Access Compliance Report

Public Rights-of-Way

Intersection ID: 12165	Main Street: E_15TH_ST	Cross Street: HARRILL_ST	Location: S
ADA ID: E079FCAAB50B	Ramp Type: PerpDiag	Initial Pass/Fail: Fail	Overall Compliance: No
		Severity Score: 8.75

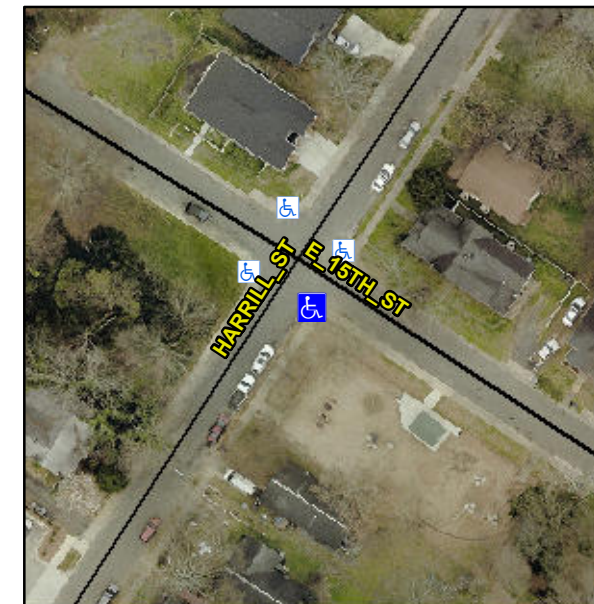
Possible Solutions:

Remove & Replace Curb Ramp With Two New Directional Ramps or Equivalent.

R304.5.1

Compliance	Description	Data	Compliance	Description	Data
N/A	Ramp Length (in)	36.0	Yes	Ramp Slope (%)	5.4
No	Ramp Width (in)	39.0	Yes	Ramp XSlope (%)	0.9
N/A	Flare Type LT	N/A	N/A	Flare Type RT	N/A
N/A	Flare Slope LT (%)	N/A	N/A	Flare Slope RT (%)	N/A
N/A	Flare Traversable LT?	N/A	N/A	Flare Traversable RT?	N/A
N/A	Landing Length (in)	N/A	N/A	DWS Provided?	N/A
N/A	Landing Width (in)	N/A	N/A	DWS Contrast?	N/A
N/A	Landing Slope (%)	N/A	N/A	DWS Length (in)	N/A
N/A	Landing X Slope (%)	N/A	N/A	DWS Full Width?	N/A
N/A	Landing Curb? (Y/N)	N/A	N/A	DWS Offset (in)	N/A
N/A	Shared Landing?	N/A			
N/A	Gutter Ponding?	Yes	N/A	Gutter Slope (%)	N/A
N/A	Gutter Lip Ht (in)	0.5	N/A	Gutter X Slope (%)	N/A
N/A	Painted X Walk1?	No	N/A	Painted X Walk2?	No
	X Walk 1 Direction	To NE		X Walk 2 Direction	To NW
N/A	X Walk 1 Width (in)	N/A	N/A	X Walk 2 Width (in)	N/A
	X Walk 1 Slope (%)	3.4		X Walk 2 Slope (%)	1.9
	X Walk 1 X Slope (%)	0.2		X Walk 2 X Slope (%)	0.2
